# **A G E N D A**

## **Architectural Review Board**

**February 28, 2023 – 5:30 p.m.**

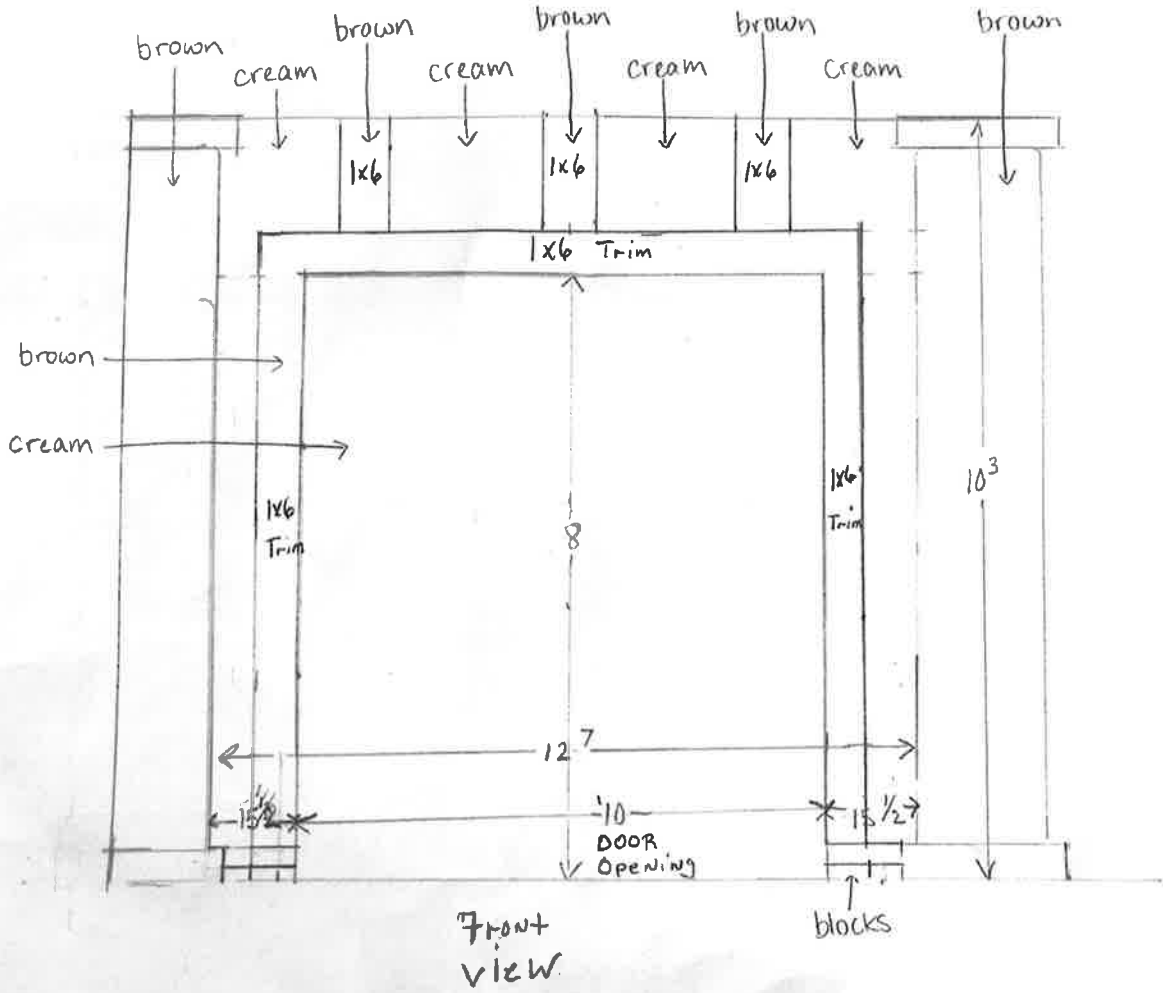
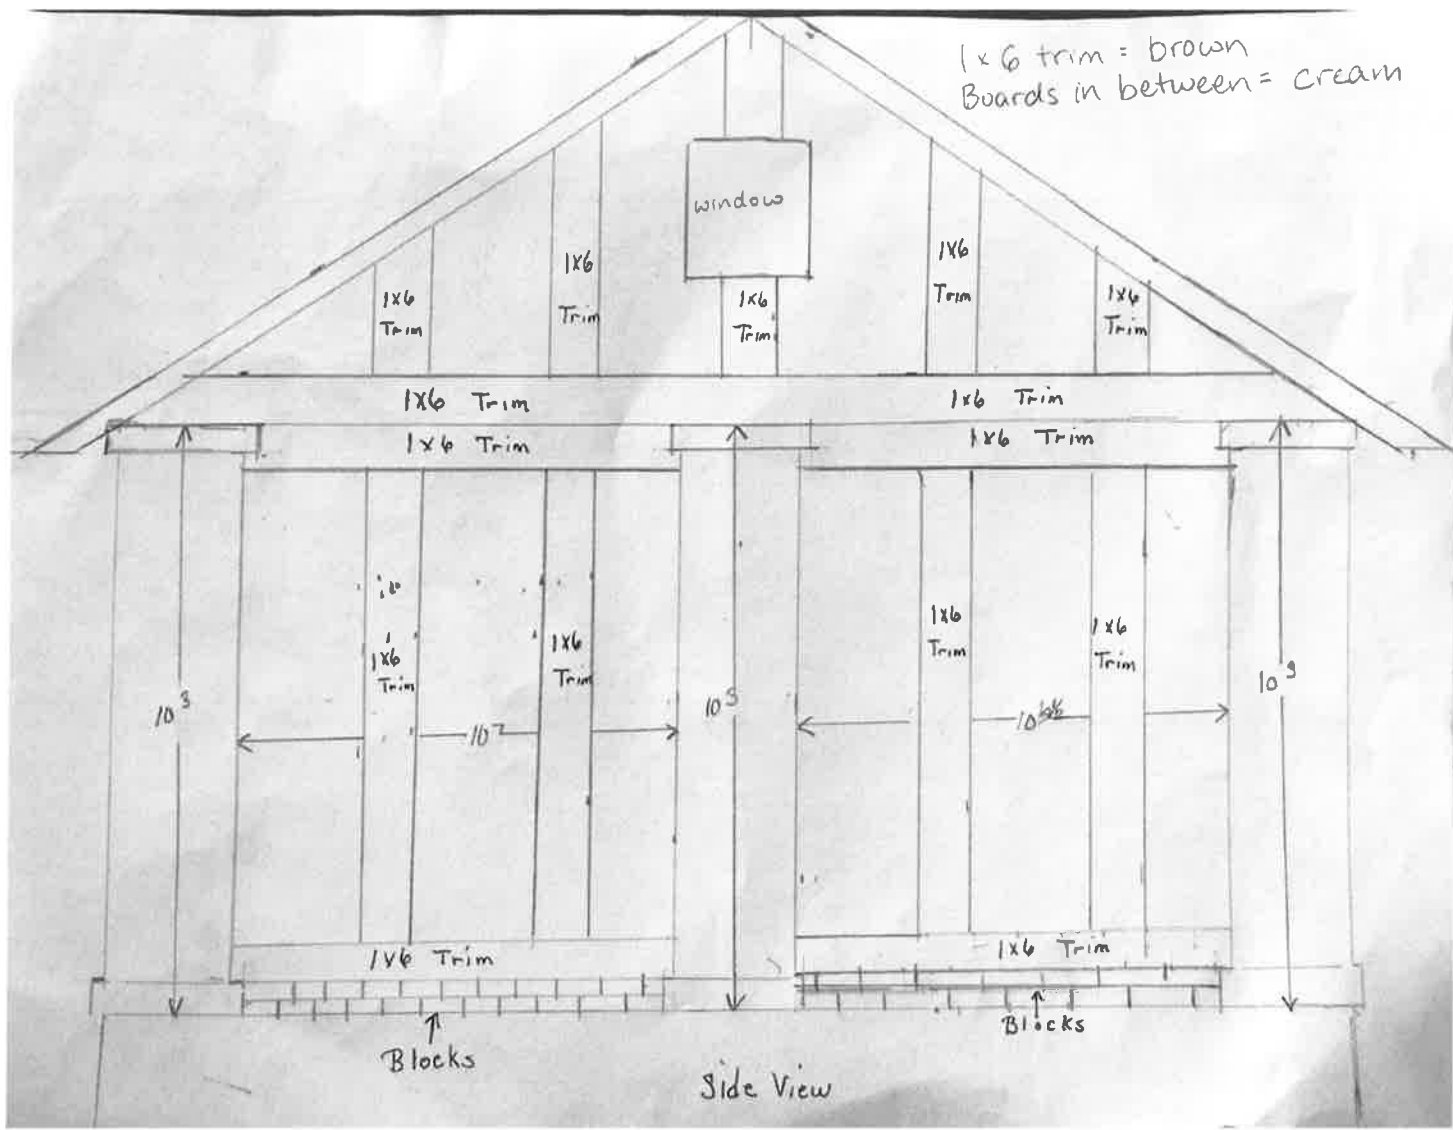
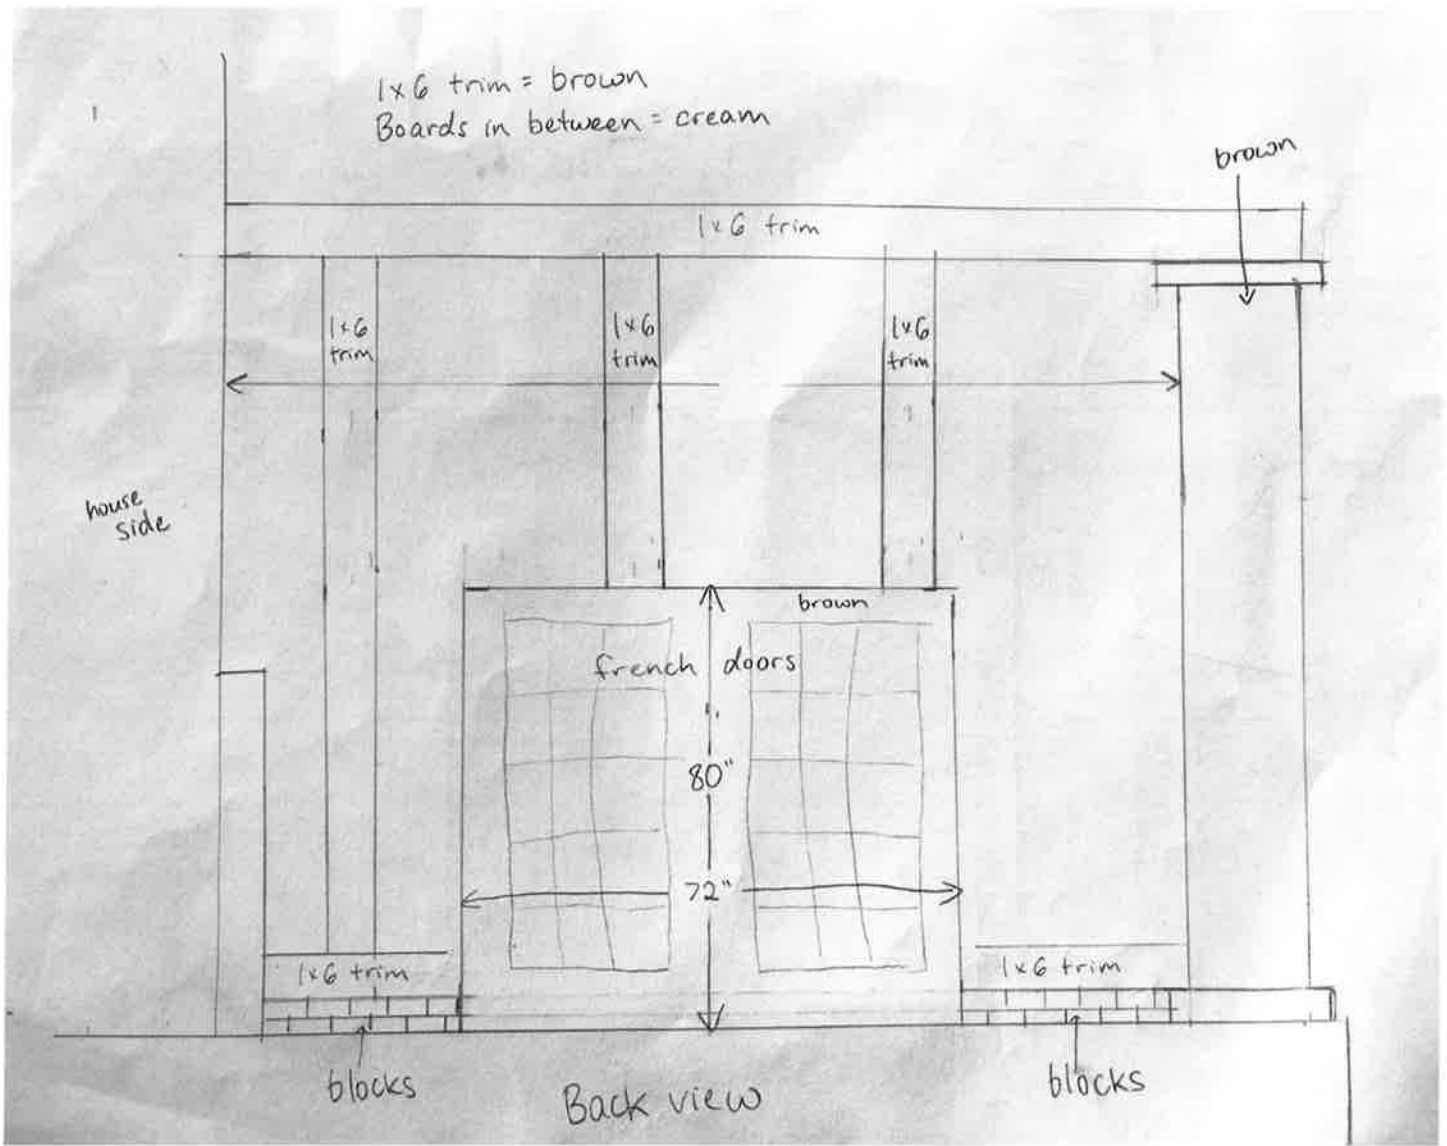
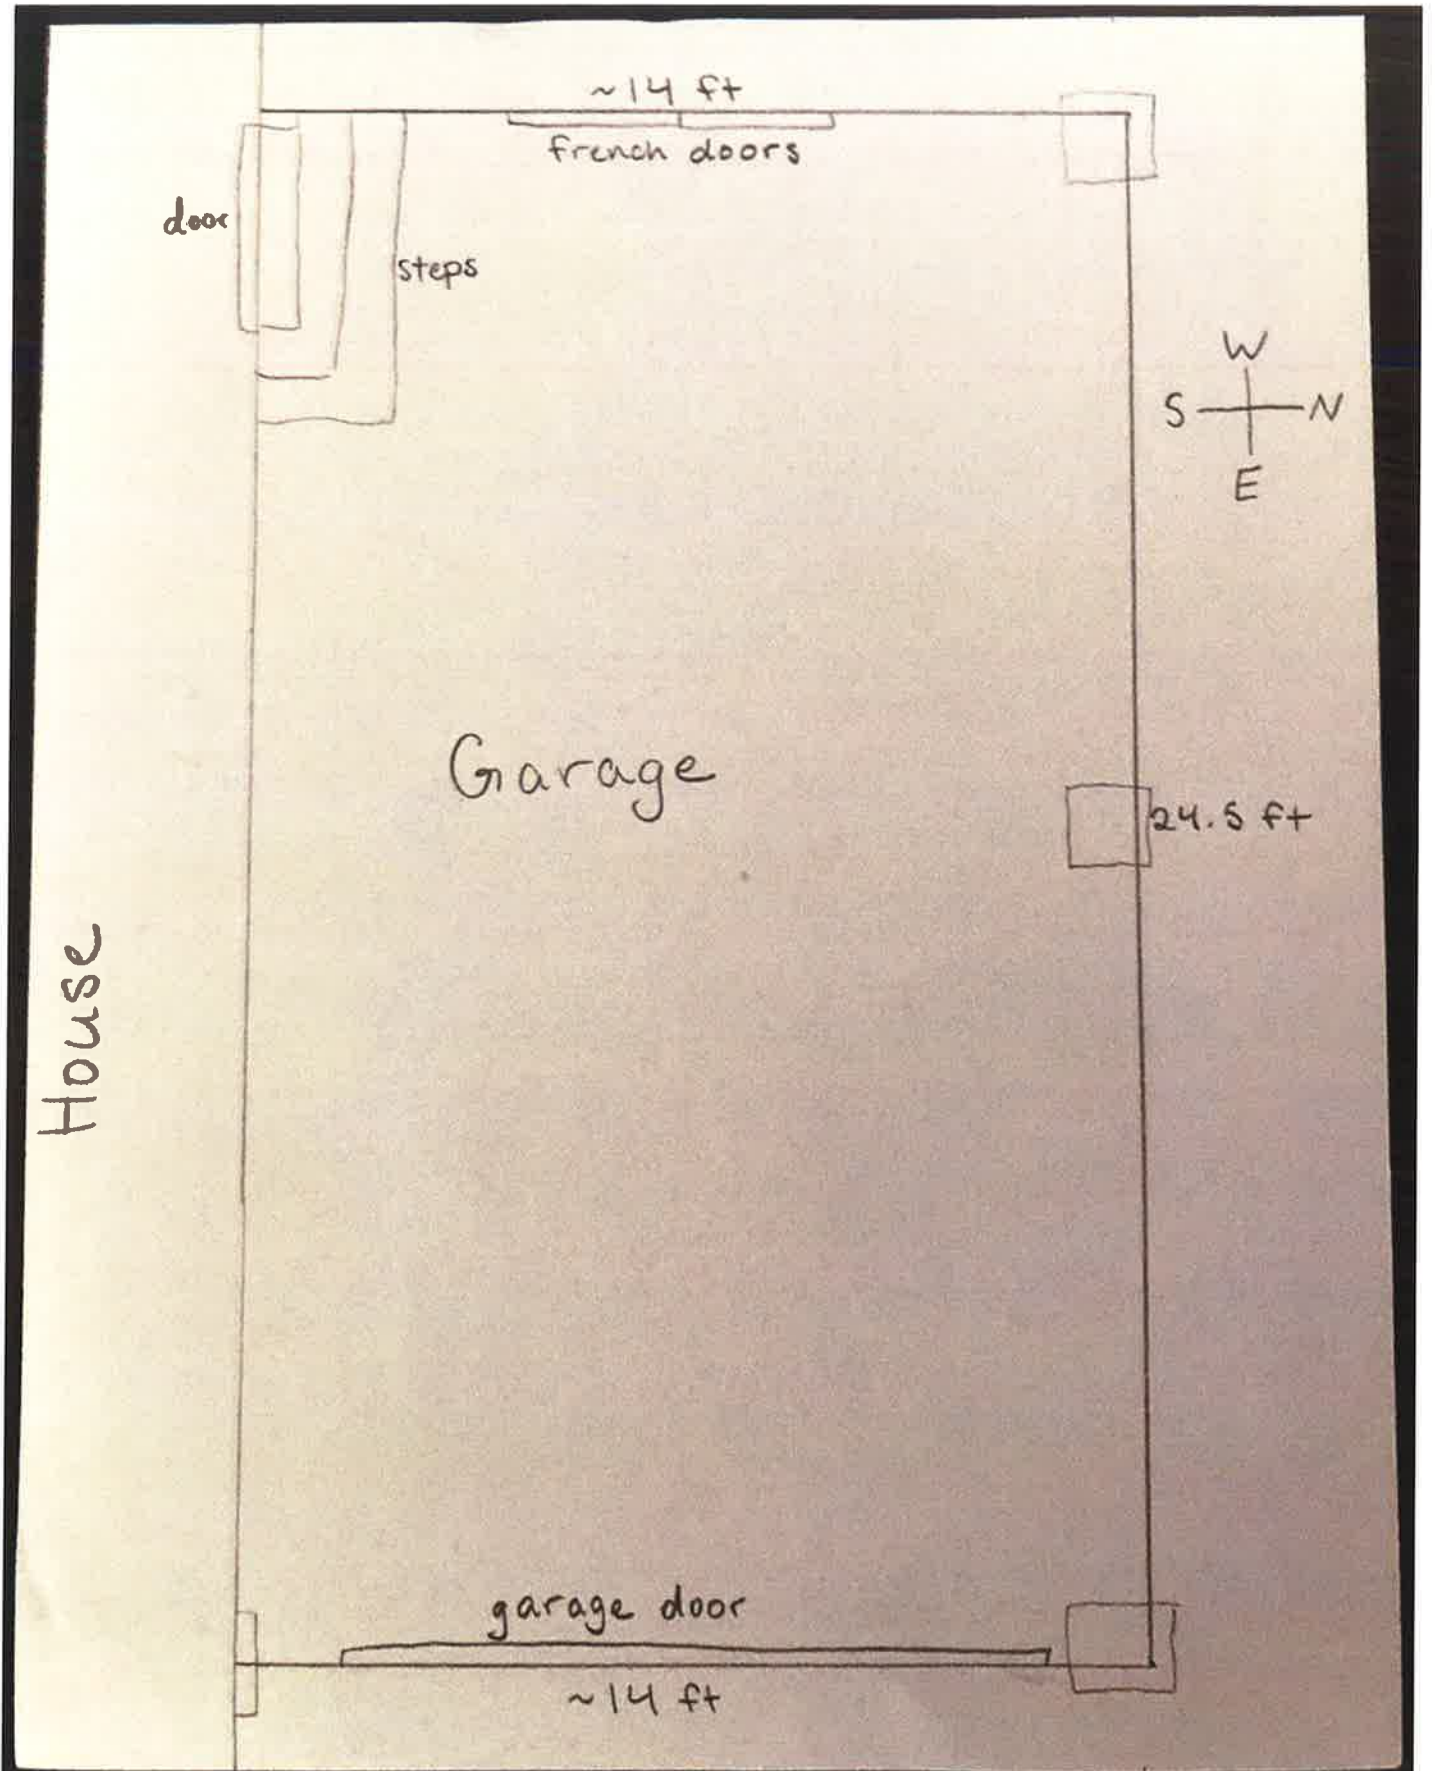
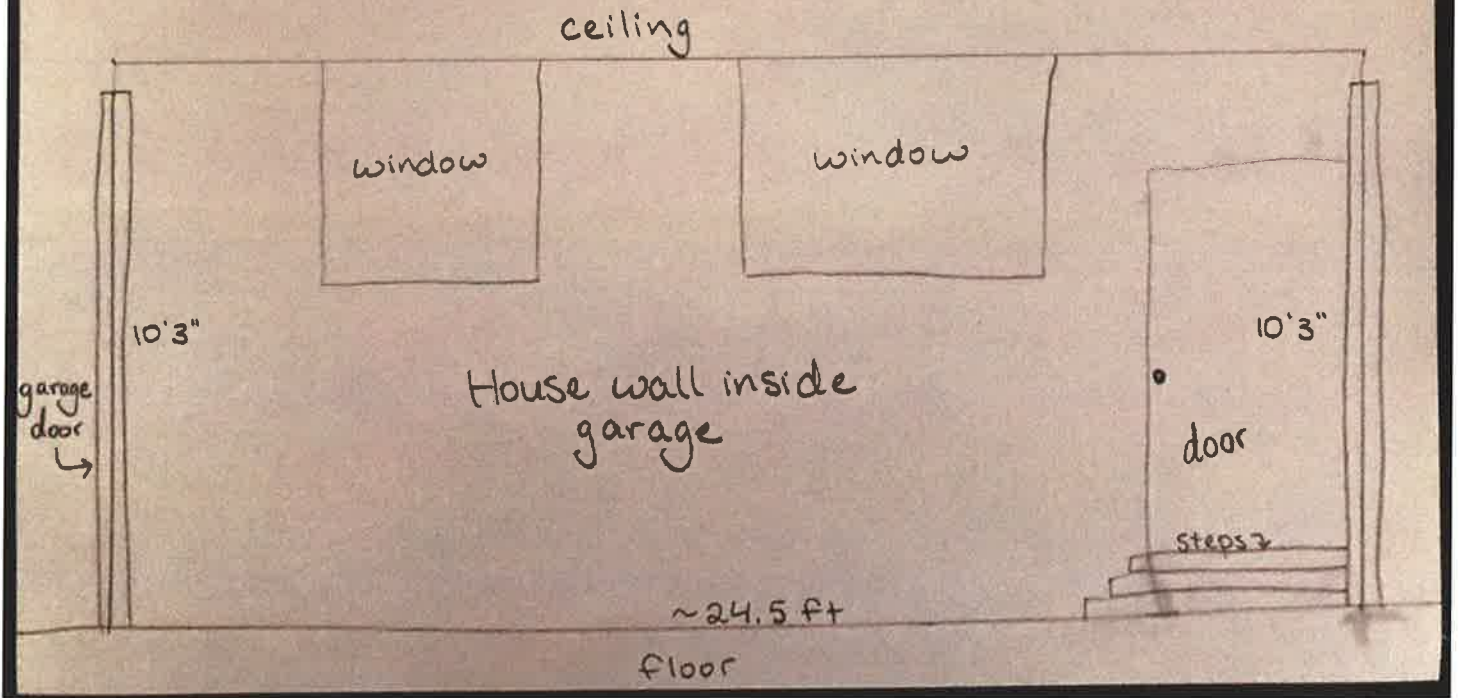
- would like to convert the carport to a garage. The front elevation will have a traditional steel garage door that is 10’ wide by 8’ high with no windows. It will be painted to match the cream on the house. The side elevation will be board and batten Hardi-board painted to match the house. The rear elevation will have a French door painted to match the trim color on the house and the rest will be board and batten like the side elevation. A small wall in the rear of the carport will be removed.

- No objection to the privacy fence or gutters.
- A street-facing garage door is a mid-century modern addition to residential language in the US. The current carport is proportionate and well designed to the historic house. Enclosing it to make a garage would not be appropriate.
- Widening the driveway would have an adverse effect to the appearance of the house. Although it is an annoyance to stack and back cars into the street, your street is wide enough and substantially residential in nature that would accommodate that.

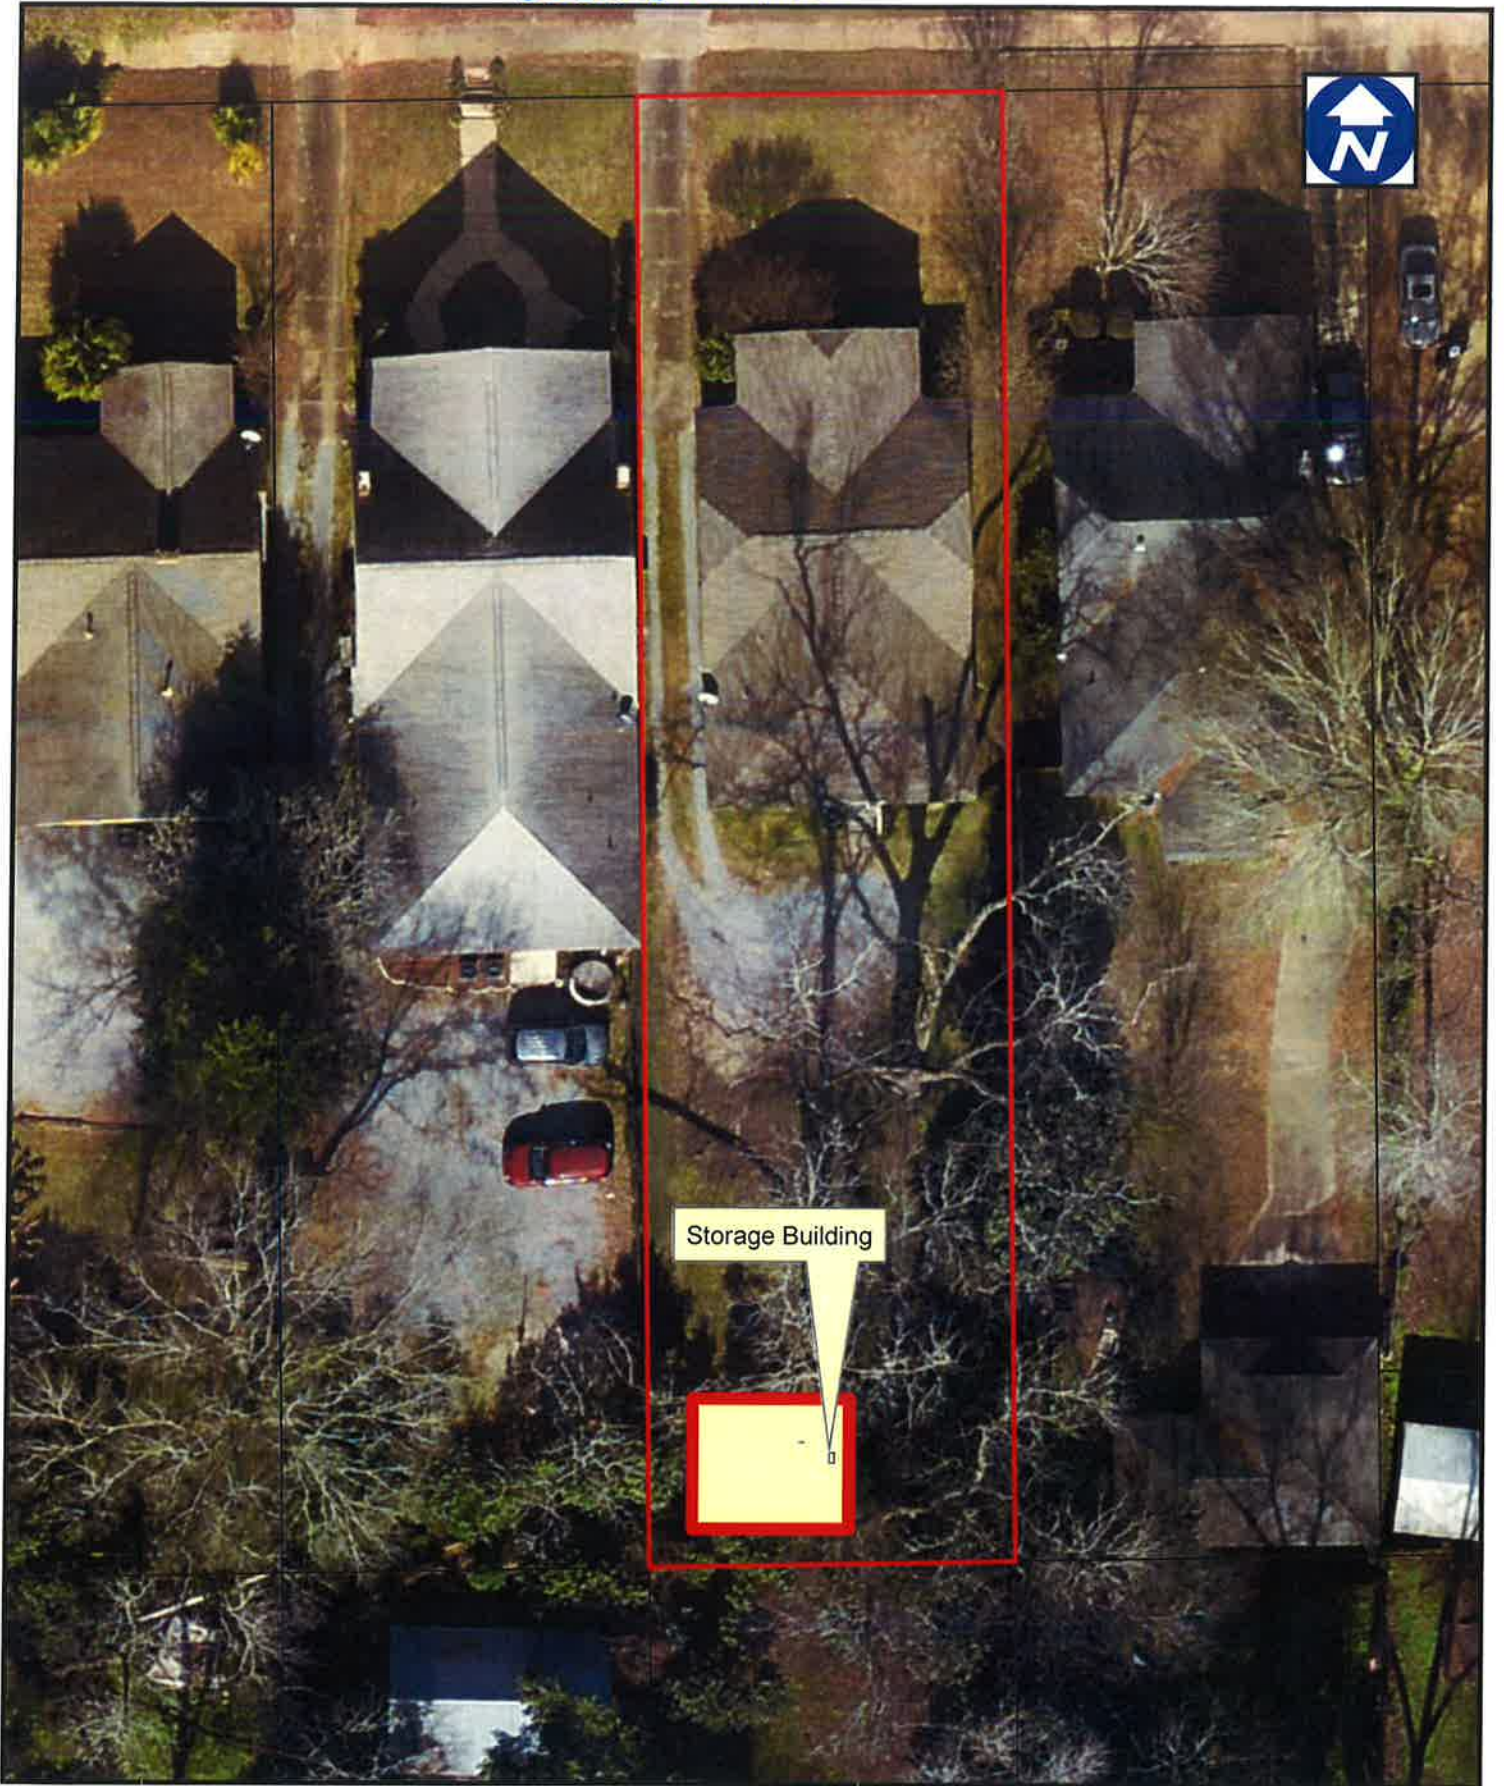
**REMARKS:** The petitioner is requesting permission to construct a 16' x 20' storage building with a covered porch area at the rear of the property on an existing concrete slab. The building will have 8" OSB fiber board siding with 6" reveal painted to match the house. It will have a weathered wood 3-tab shingle. Two windows are proposed, American Craftsman 6:6 vinyl clad with grills. The proposed door is a standard wood exterior door. There are 4 porch columns proposed with a railing. Petitioner was advised to bring a sample of the window to the meeting.

- What are the dimensions for the rails and columns on the porch?
